Re: March 2018 Preliminary Draft Report
2017 Inventory of Renewable Energy Generators Eligible for the Maryland RPS

In response to the Power Plant Assessment Division of Maryland's Department Natural Resources Request for Comments on the above referenced Draft Report, Brookfield Renewable ("Brookfield") is pleased to submit the following comments and recommendations.

Chart 1
Existing Non-Solar Certified Tier 1 Generation Capacity (MW)²

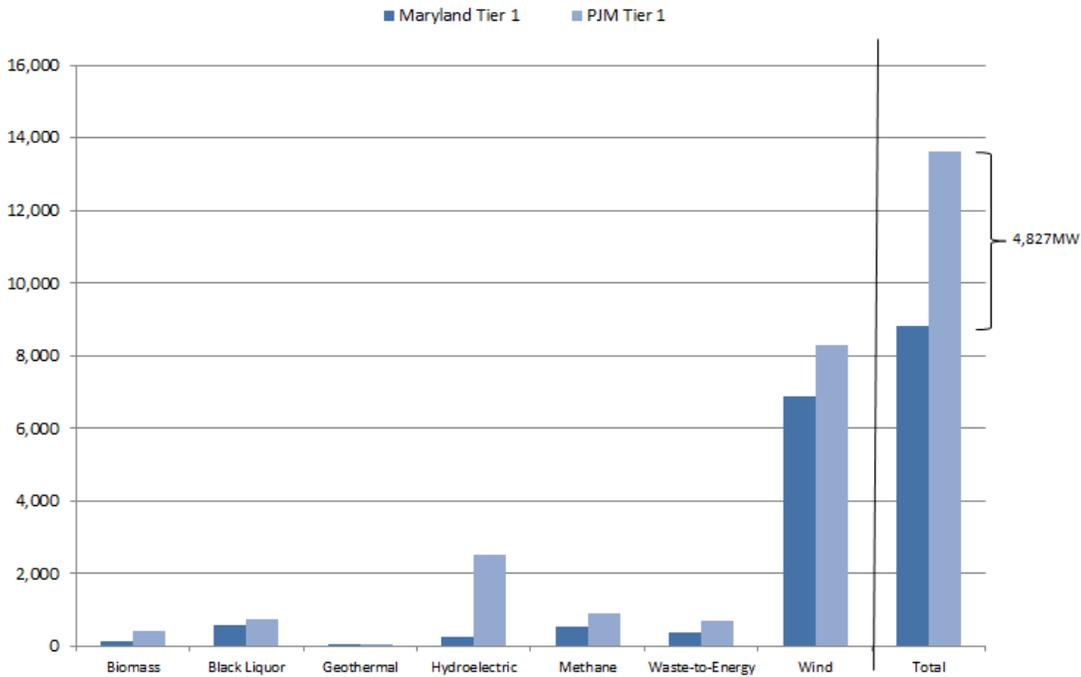
1. The supply of available resources includes only those resources that are certified as Tier 1 eligible in Maryland in PJM-GATS, thereby underestimating the actual PJM supply.

This assumption is problematic as it causes a significant quantity of Tier 1 resources to be excluded from the supply analysis. Resources that are eligible under Maryland’s program requirements may instead choose to register in other PJM states where their RECs are sold. In addition, differences in resource eligibility criteria may cause some resources to be considered Tier 1 eligible in some PJM states despite being excluded from Maryland’s Tier 1 program. Nevertheless, these resources are available to contribute to the RPS programs of other PJM states and should be included in the analysis to have an accurate account of the available supply. Brookfield’s analysis suggests that changing this one assumption alone could result in almost 5,000MW of additional existing Tier 1 supply.

**Chart 2
Brookfield’s Analysis compared to
Exeter’s Analysis of Non-carve-out Tier 1 Supply and RPS Obligation
(2018-2030) (GWh)**

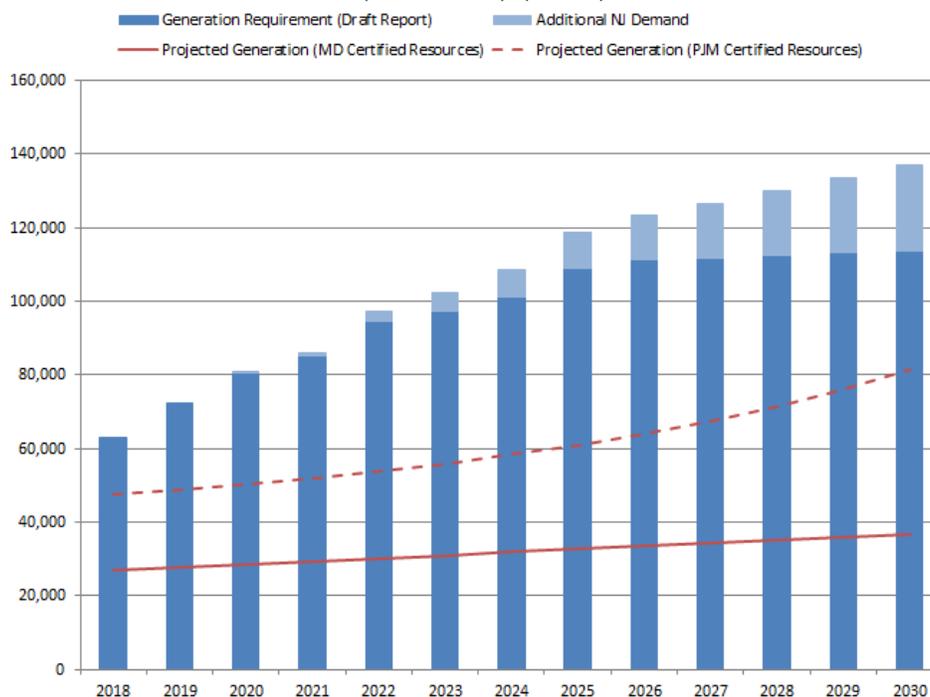
Brookfield’s analysis of PJM certified resources, represented by the dashed red line in Chart 2 above, reveals a larger existing supply (an additional 20TWh in 2018) as compared to Exeter’s analysis, represented by the solid red line. This significantly reduces the annual growth rate of renewable energy generation required for all PJM states to meet their RPS obligations in 2020 to approximately 20 percent, rather than 46 percent in Exeter’s Draft Report. Nonetheless, Maryland and other PJM states still cannot collectively meet their non-carve-out Tier 1 requirements.

Chart 3
Brookfield’s Adjusted Baseline as compared to
2018-2019 Legislative Initiatives
2030 Obligation (GWh)

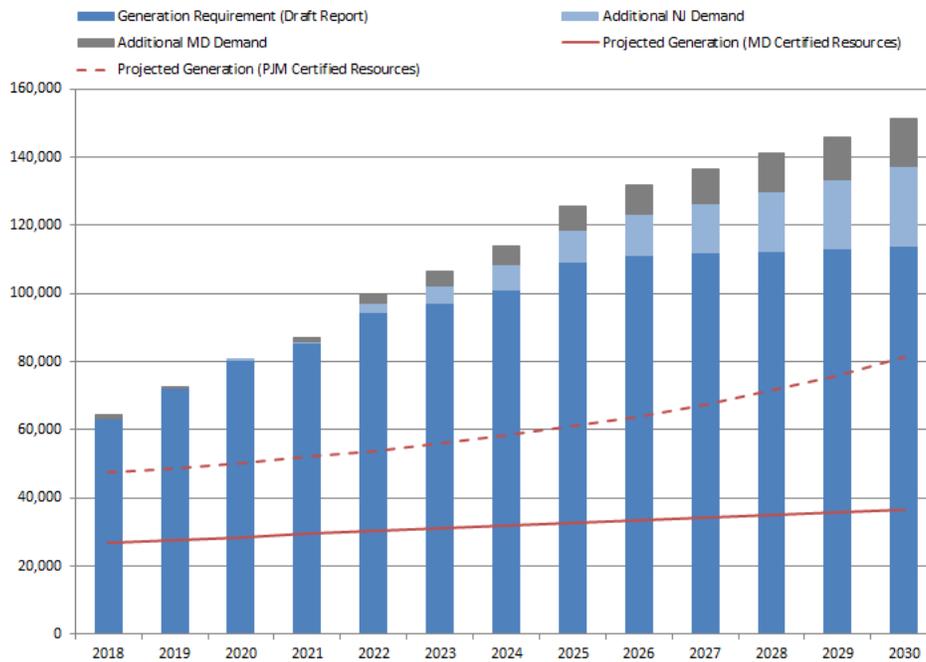
In the Draft Report, Exeter models an RPS target of 50 percent by 2030 to measure potential impacts of an expansion of Maryland’s RPS requirements, should the State Legislature approve such an increase⁴. Adding the 50 percent by 2030 target to Brookfield’s preceding non-carve-out Tier1 supply analysis results in an additional 14TWh of renewable demand in PJM in 2030.

Chart 4
Expanded Tier 1 Eligibility for Hydropower⁹

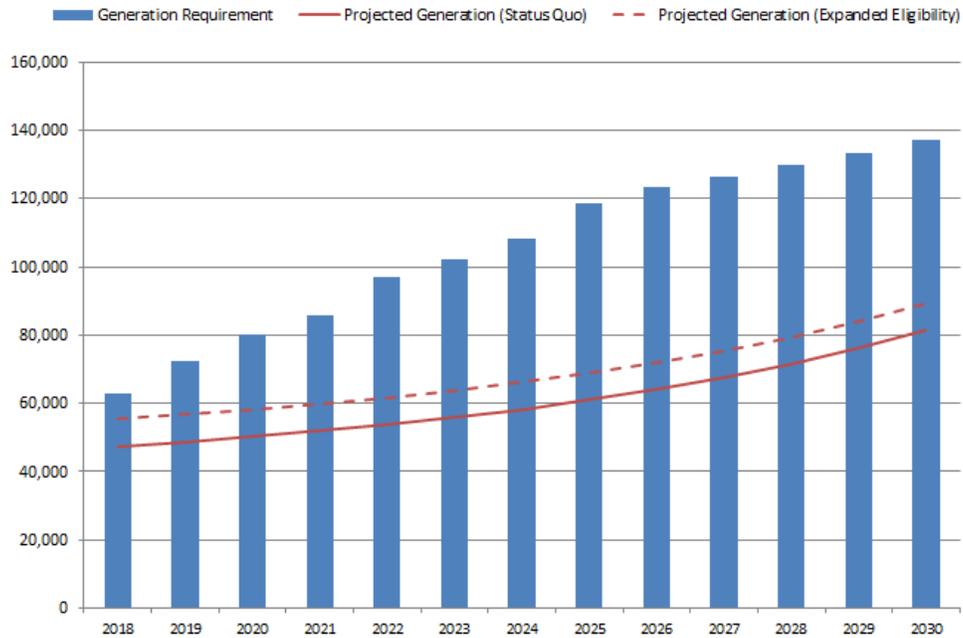
Brookfield recommends that Exeter assess the value of extending eligibility to existing hydropower resources that are not eligible under Maryland's current Tier 1 program due to the 30MW cap on hydropower facilities.

Currently over 2,000MW of hydropower is certified as Tier 2 in Maryland. Transitioning these resources to Tier 1 would help address anticipated deficiencies in non-carve-out Tier 1 resources in PJM, while maintaining incentives for the build out of new renewables. Brookfield's modeling suggests that expanding Tier 1 eligibility to include 2,000MW of additional hydropower would reduce the supply gap by about 8 percent annually on average from 2018 to 2030.

Chart 5
Annual Ratepayer Savings from
Expanded Tier 1 Eligibility for Hydropower (\$)

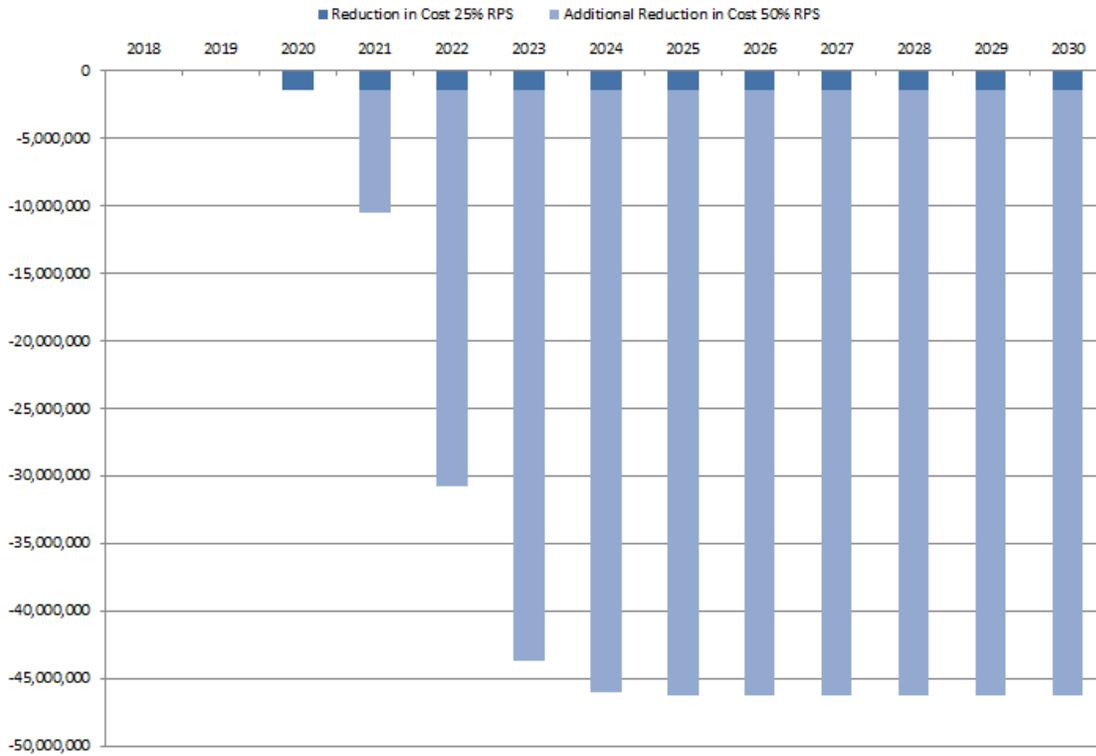
This one change alone could produce almost \$16 million in ratepayer savings by 2030, with savings potentially increasing to over \$400 million over the same period if Maryland’s RPS is expanded to 50 percent.
